APPLICATION NO.	FILING DATE	FIRST NAMED INVENTOR	ATTORNEY DOCKET NO.	CONFIRMATION NO.
10/559,850	12/07/2005	Dov Ingman	2387.0020000	1962
54089 7590 08/24/2007 BARDMESSER LAW GROUP, P.C. 910 17TH STREET, N.W. SUITE 800 WASHINGTON, DC 20006			EXAMINER LEUNG, QUYEN PHAN	
			ART UNIT 2874	PAPER NUMBER
			MAIL DATE 08/24/2007	DELIVERY MODE PAPER

Office Action Summary	Application No. 10/559,850	Applicant(s) INGMAN ET AL.	
	Examiner Quyen P. Leung	Art Unit 2874

DETAILED ACTION

FIG. 2 205

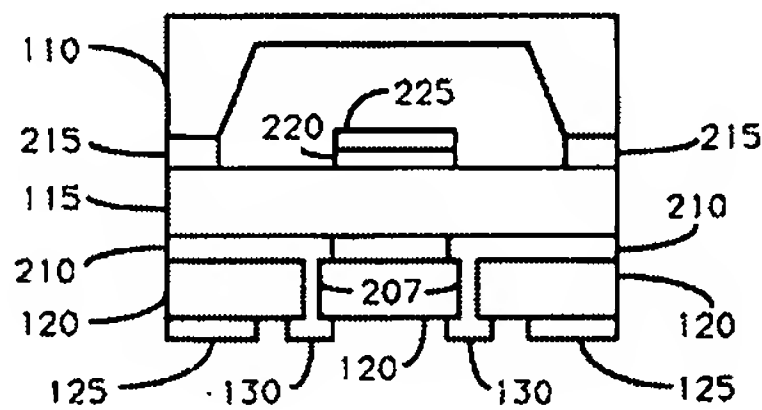
Claims 56, 60 are rejected under 35 U.S.C. 102(b) as being anticipated by Cho et al (5,414,214). Cho discloses a substrate (220), a microfabricated device (225), and an intermediate layer (110), as claimed.

Re claim 60, see col. 7 lines 55 through col. 8 line 3 for the substrate (220) being a ceramic material (ceramic mixture) or an optically transparent material (glass).
